RE: **Lot 3 Block 8, Volcano Cliffs, Unit 18, SAD 228
6504 Papagayo NW
Grading and Drainage Plan
Engineers Stamp Date 11/23/19 (D10D003O3)**

Based upon the information provided in your submittal received 11/21/19, this plan is approved for Grading Permit.

ENGINEER'S SEAL  11/21/19 DAVID SOULE P.E. #14522	LOT2 BLK8 U18 VOLCANO CLIFFS SUB 6504 PAPAGAYO ROAD N.W. GRADING AND DRAINAGE PLAN  1608 CENTRAL AVENUE SE SUITE 201 ALBUQUERQUE, NM 87106 (505) 972-0899	DRAWN BY DEM
		DATE 11-20-19 6504 PAPAGAYO RD LOT 3 BLK8 U18 VIC DING
		SHEET # C1
		JOB #

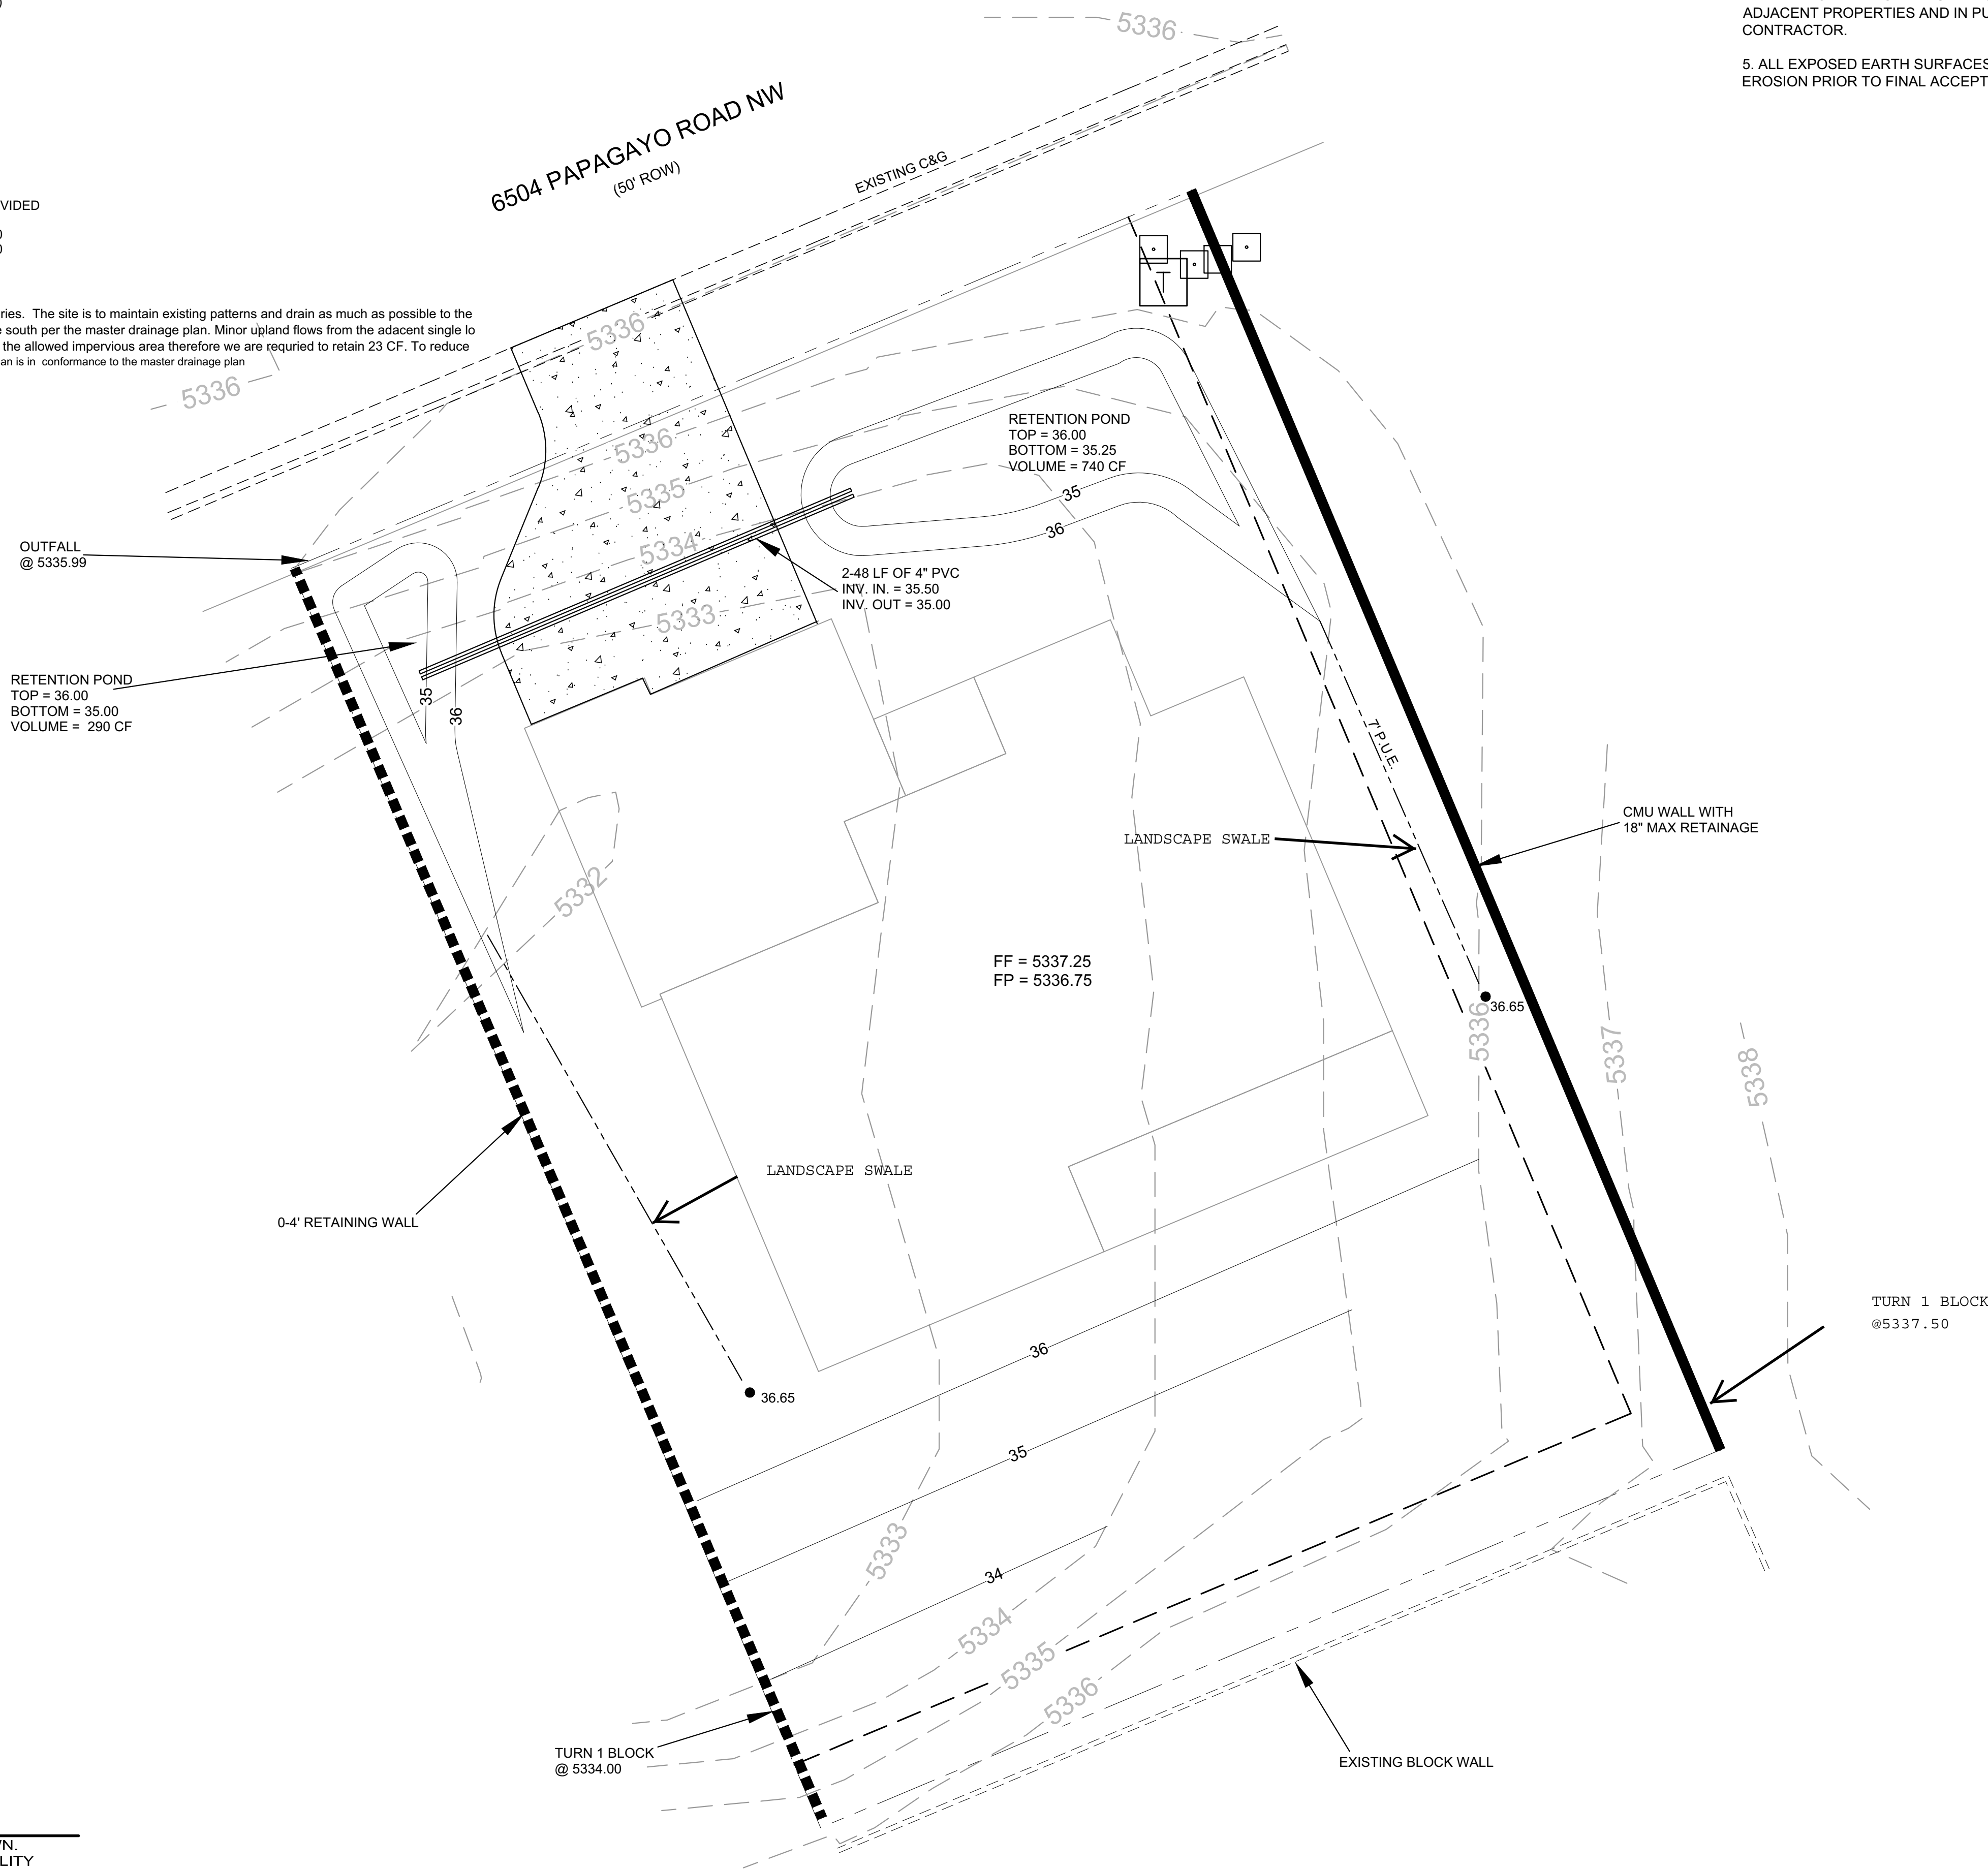
Prior to Building permit approval a Pad Certification will be required, provided by the Engineer or a registered Land Surveyor.

Reiterate to the Owner/Contractor that a separate permit for a garden/retaining wall must be obtained with the approved G&D plan and Pad Certification. Also, if a swimming pool is to be placed the grading and drainage plan will change and will need to be resubmitted.

Prior to Certificate of Occupancy release, Engineer Certification per the DPM checklist is required.
